# SERVICE LETTER

No. 565

Piper Aircraft Corporation

Rear Cabin Dome Light Mounting Screw

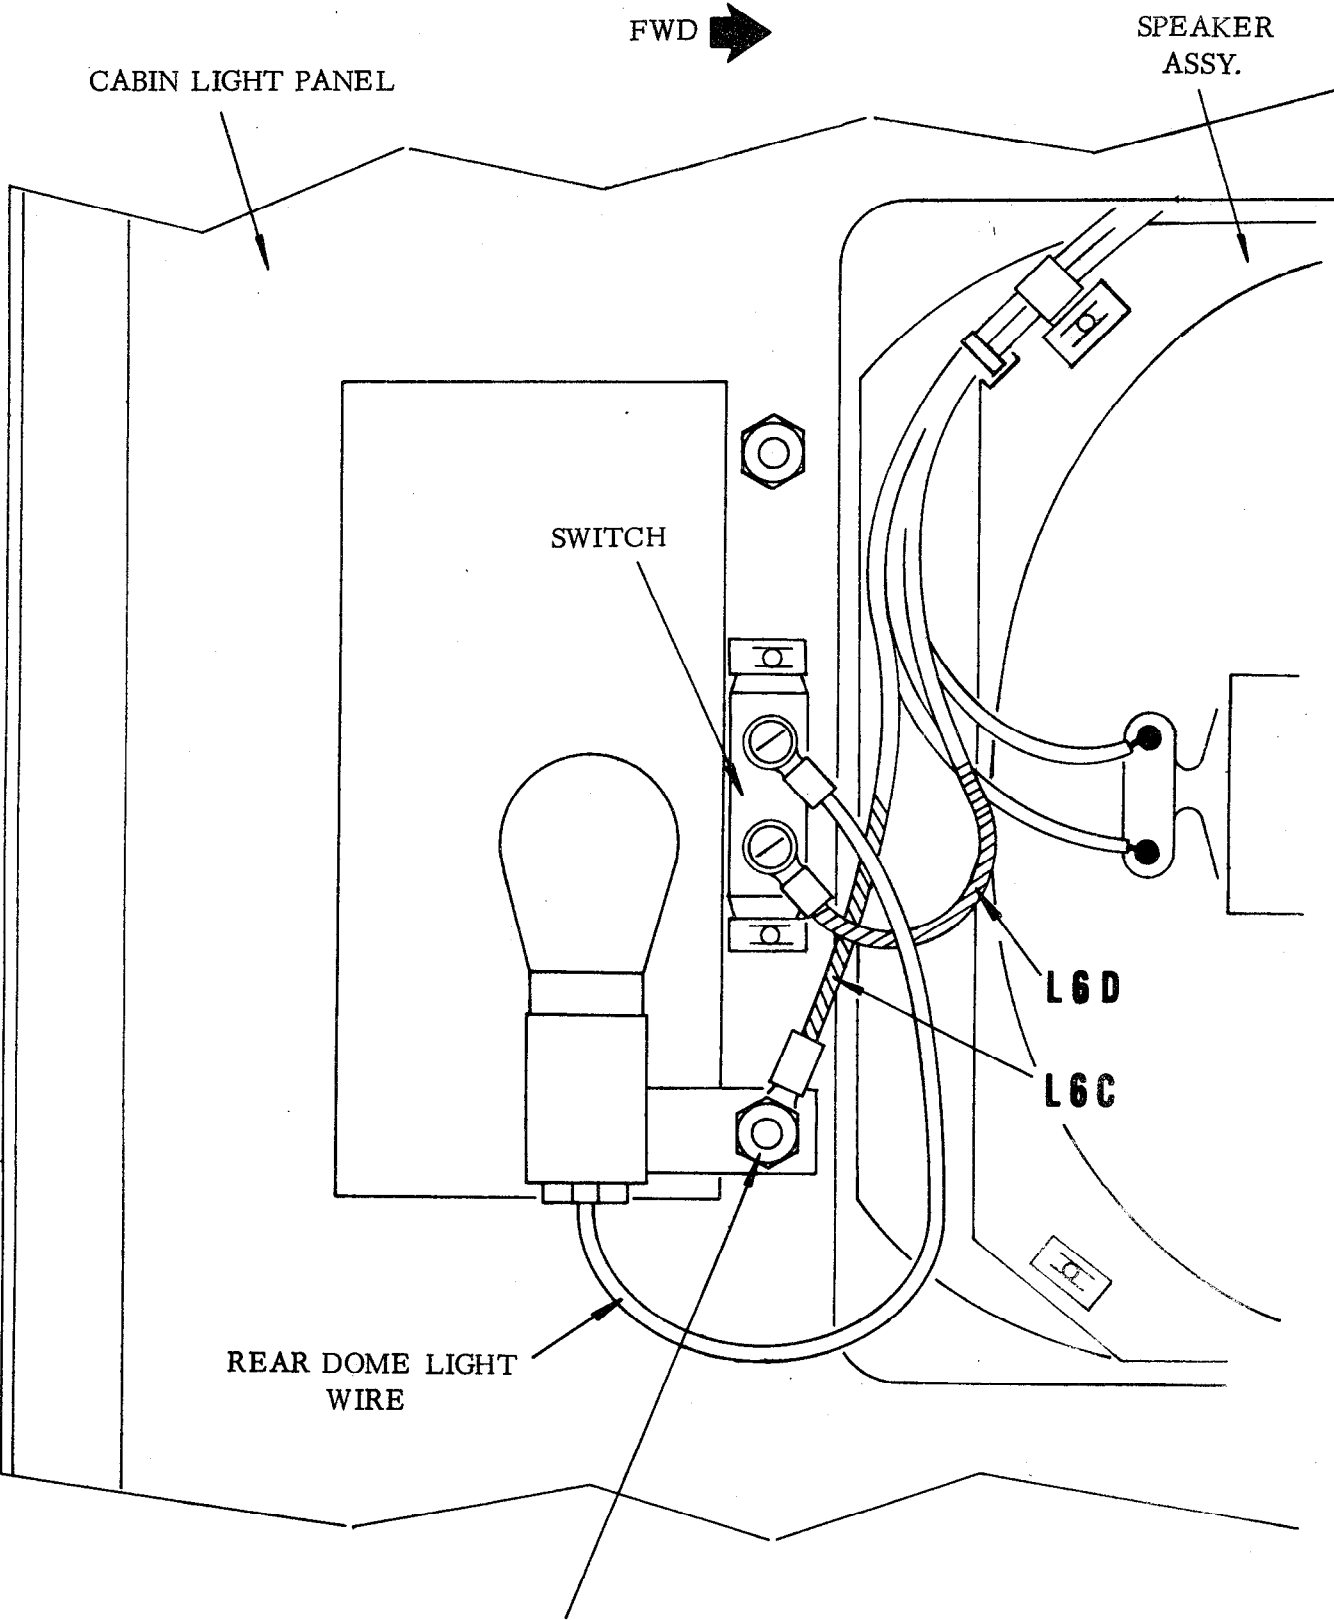
To determine if a voltage potential exists at the rear cabin dome light mounting screw.

1. Apply volt meter leads to the rear cabin dome light mounting screw and to an appropriate airframe ground (as indicated in sketch on reverse side of this letter).
2. Turn the aircraft master switch on, and check to see if the volt meter registers a voltage reading.
3. If a voltage reading does exist, it will be necessary to lower the cabin light panel and revise the rear cabin dome light wiring per the sketch on the reverse side of this letter.
4. If a voltage reading is not apparent per numbers one and two, above, no further action is required.

APPLY THE VOLT METER  
LEAD TO THE HEAD  
OF THIS MOUNTING SCREW.
